## ADMINISTRATIVE REPORT

**Title:** DAV 24-109415\C – 600 Gertrude Avenue

**Issue:** For consideration for a Variance associated with a 6-unit multi-family dwelling

### 1 Site Plan

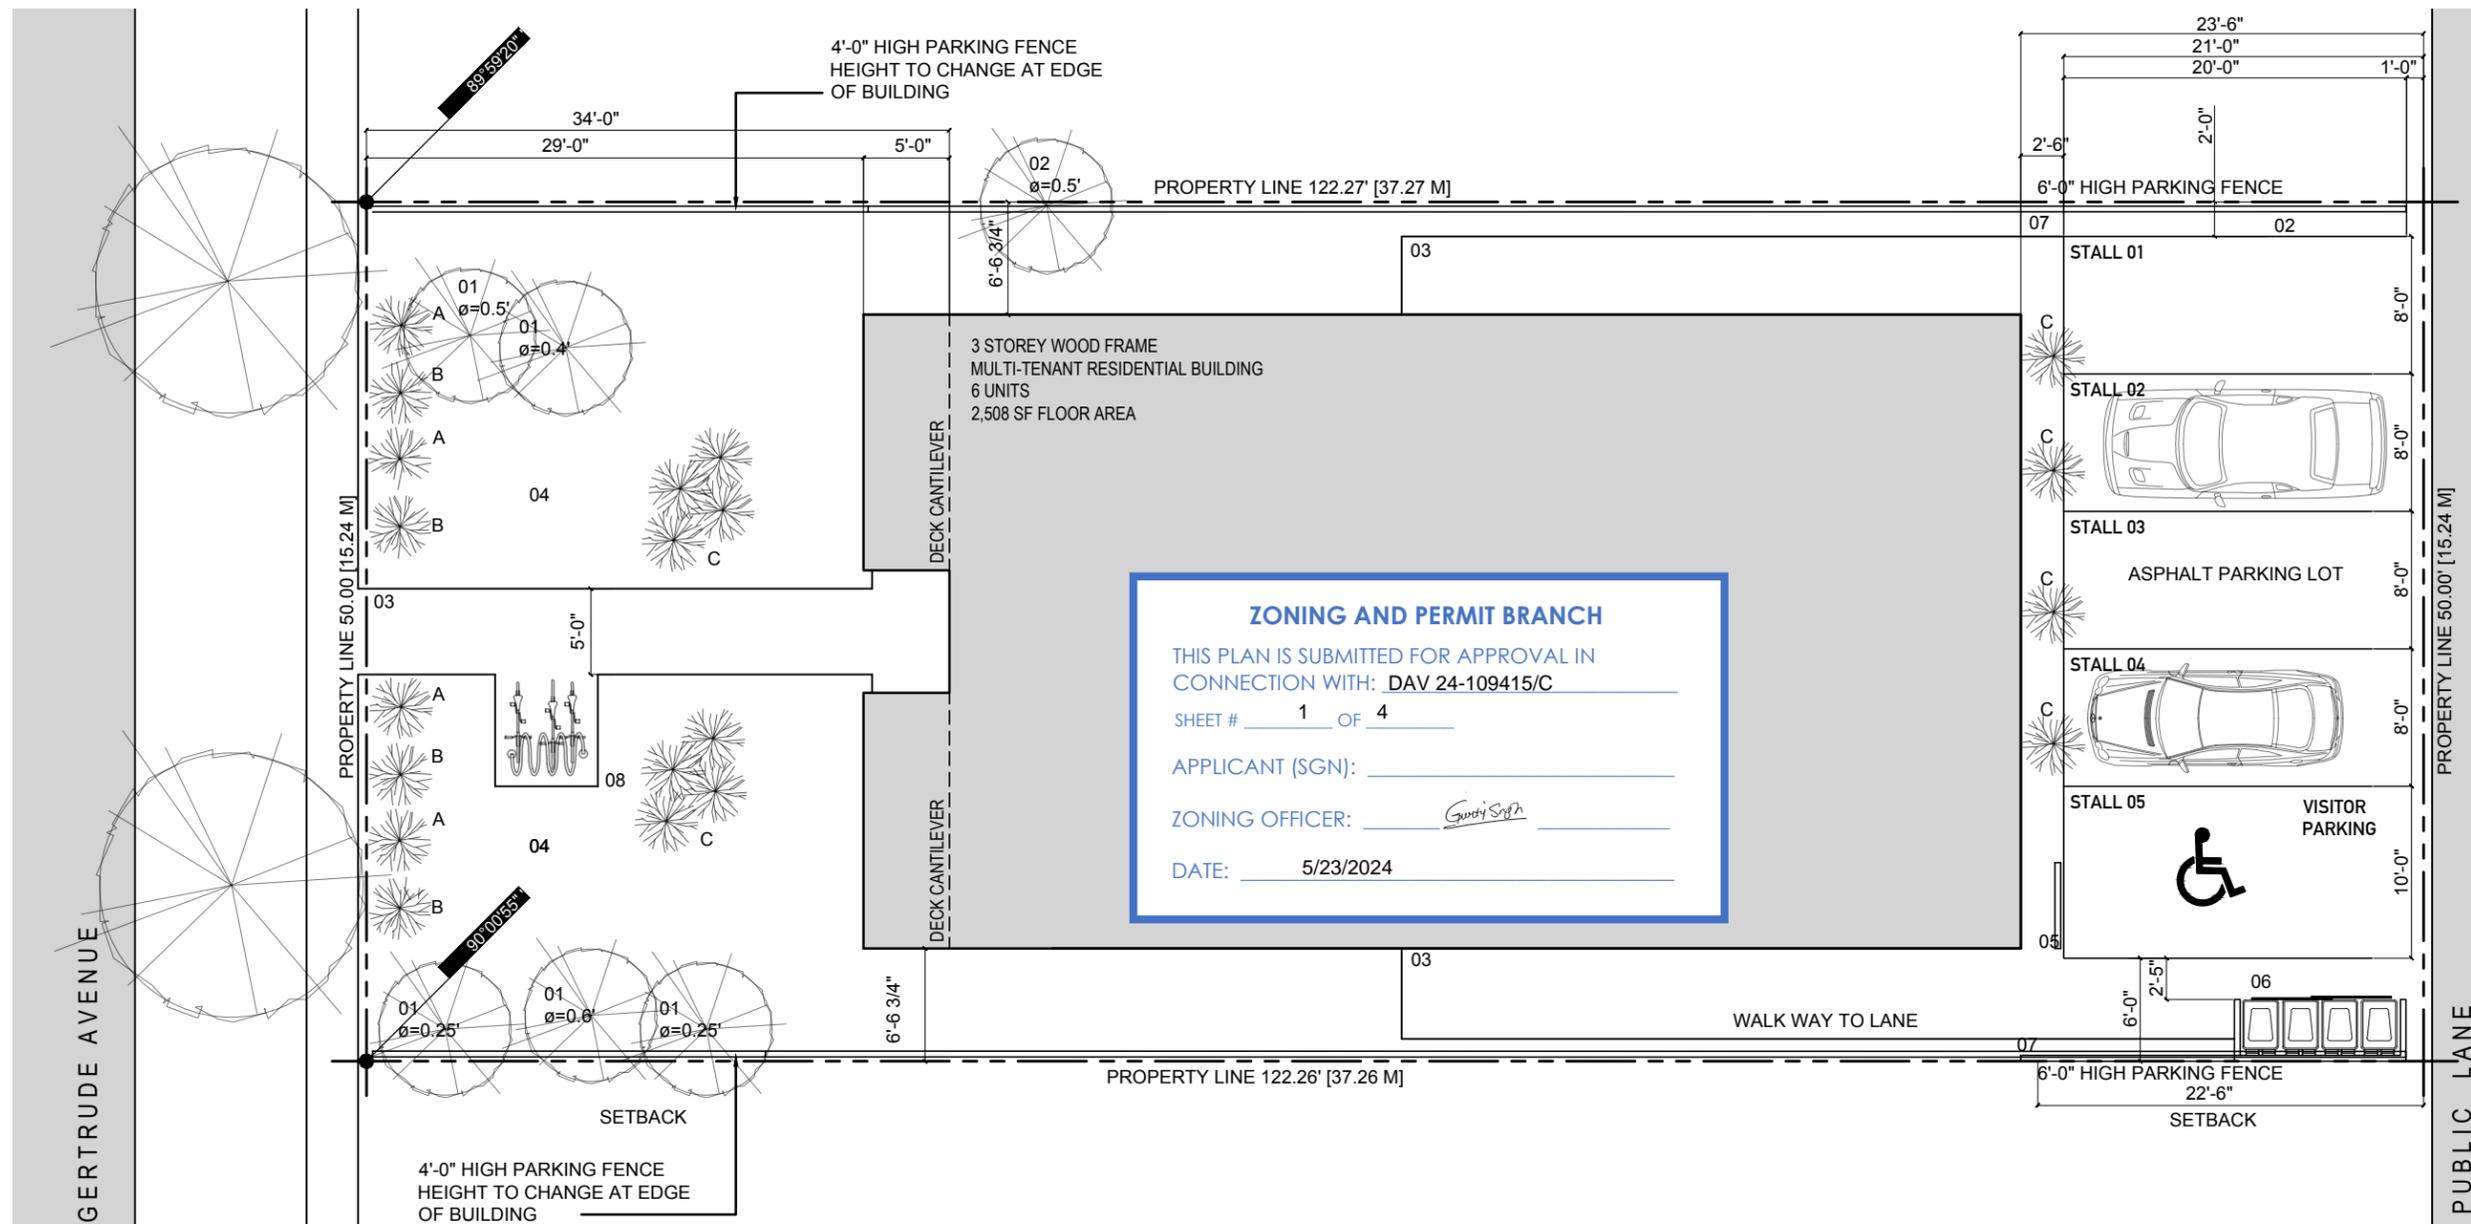
Per the front yard alignment, the required front yard is 40 feet. The applicant proposes a front yard of 34 ft., therefore a variance is required.

In the “R2” District, the minimum rear yard is 25 ft. The applicant is proposing a rear yard of 23.5 ft., therefore a variance is required.

The required number of parking stalls for this development is 7. The applicant is providing 5 stalls, therefore a variance is required.

Parking stalls for multifamily development have a required length of 23 ft. The applicant is proposing a length of 21 ft., therefore a variance is required.

10 ft. is required between parking stalls and a habitable room with a window less than 5 ft. above grade. The proposal provides rear stalls 2.5 ft. to such a window, therefore a variance is required.

Parking that is located within 20 ft. of a lot line abutting or adjacent to a residential zoning district requires a landscaped buffer. The applicant is not providing such a buffer at the rear, therefore a variance is required.

The North of Corydon Residential design guidelines allow front yards of new developments to be located up to 5 ft. forward of the average of the two adjacent dwellings. In this case, the average of the two adjacent dwellings’ front yards is 39 ft. The applicant’s proposed 34 ft. is within 5 ft. of this, meeting the standard. The Urban Planning Division approves this variance.

A rear yard of 21 ft. is a commonly requested and approved variance in mature neighbourhood contexts such as this. 21 ft. can still provide sufficient space for parking off the lane with a small variance. (See “Length of stalls off the lane”, below). For this reason, the Urban Planning Division approves this variance.

The Urban Planning Division generally supports a minimum parking ratio of 0.8 stalls per dwelling unit in the Corydon area, which enjoys access to quality transit and cycling options. With the provision of 5 stalls for 6 units, the provided parking ratio is 0.83. The Division therefore approves this variance.

The Urban Planning Division often supports a length of 21 ft. for off-the-lane stalls, in cases where lot size constraints pose a challenge. The Division believes that 21 ft. will provide functional space to meet the intent of the Zoning By-Law regulation which is to provide space for longer vehicles and snow storage. The Urban Division therefore approves this variance.

On compact infill sites such as this one, parking is often by necessity provided off the lane. In doing so, it is difficult to avoid locating parking stalls close to the rear building wall. The Division will often support variances in situations like this where the constraints of the site present a challenge due to smaller lots sizes typical in Mature Communities. The Division therefore approves this variance.

Although buffering is required for parking areas located within 20 ft. of adjacent residential, in this case the applicant has no opportunity to plant landscaping or erect a fence at the rear lot line due to the parking off the lane. The Urban Planning Division therefore approves this variance.
